Access Compliance Report Public Rights-of-Way (Curb Ramps)

Main Street: 17TH_ST Cross Street: GERSHON_PL Location: NW

ADA ID: RPRK220125122546 Ramp Type: Type 4 - Parallel Initial Pass/Fail: Pass Overall Compliance: No Severity Score: 0

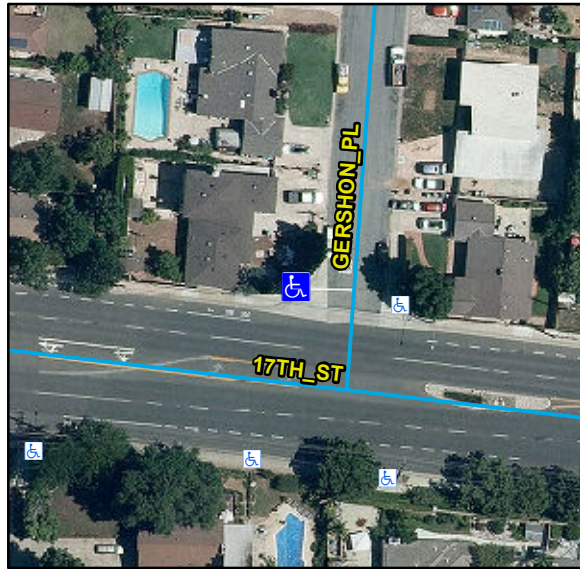
Crossing 1 Slope (%)	7.6		Crossing 2 Slope (%)	7.7
	Crossing 1 Cross Slope (%)	0.2		Crossing 2 Cross Slope (%)	1.1
Yes	Gutter Ponding	No	Yes	Curb Slope	1.5
Yes	Gutter Lip Height (in)	0		Road Run Slope (%)	2
Yes	Gutter Run Slope (%)	2.2		Road Cross Slope (%)	1.2
No	Gutter Cross Slope (%)	3	Yes	Perpendicular Joint Present	Yes
Yes	Overall Surface Condition	Acceptable			
	Cross Gutter Present?	Yes		Spandrel Present?	Yes
	Replace Cross Gutter?	No		Replace Spandrel?	No

Remove & Replace Gutter.
